Application Number:	24/00144/CPL
Location:	566 Manchester Old Road, Middleton, M24 4PJ
Proposal:	Certificate of lawfulness for a proposed rear dormer and two roof lights on the front roof slope
Applicant:	Mr Brian Gibson
Case Officer:	Bob Melling
Recommendation:	Grant

Certificate of lawfulness is sought for a flat roof dormer to the rear roof slope of the host dwelling.

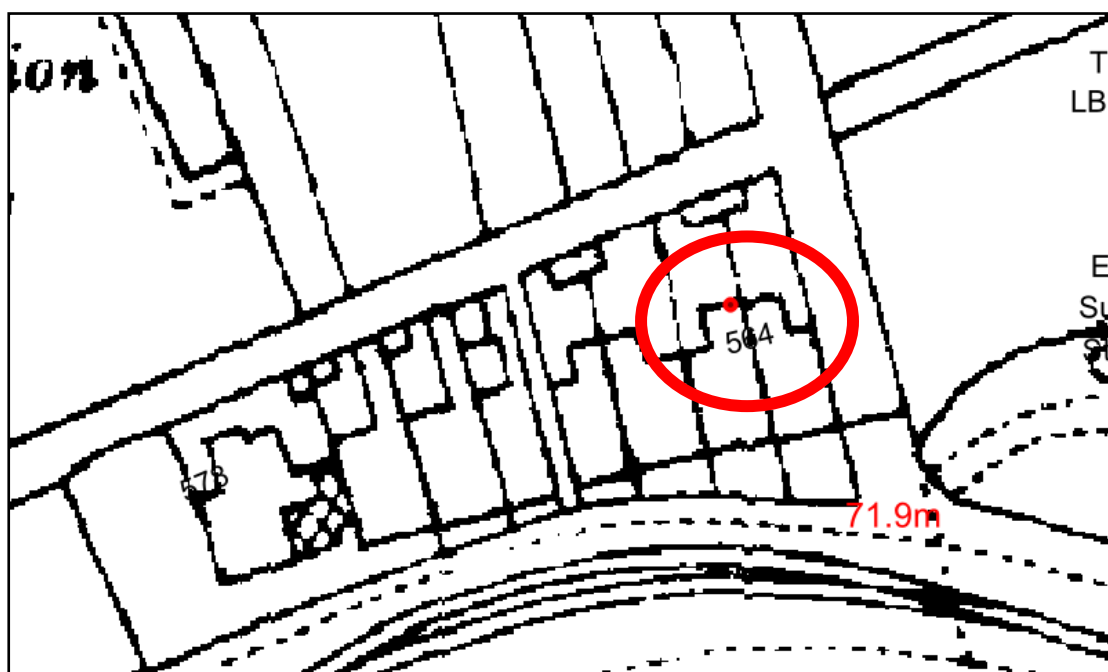
The application relates to no. 566 Manchester Old Road, a two-storey terraced dwelling located in Middleton. The dwelling is adjoined by no. 564 Manchester Old Road to the east, no. 568 Manchester Old Road to the west and faces the highway to the south. The rear boundary of the curtilage borders an unadopted street. The host dwelling benefits from an original two-storey outrigger, which can be seen in the following historic map dated 1929.
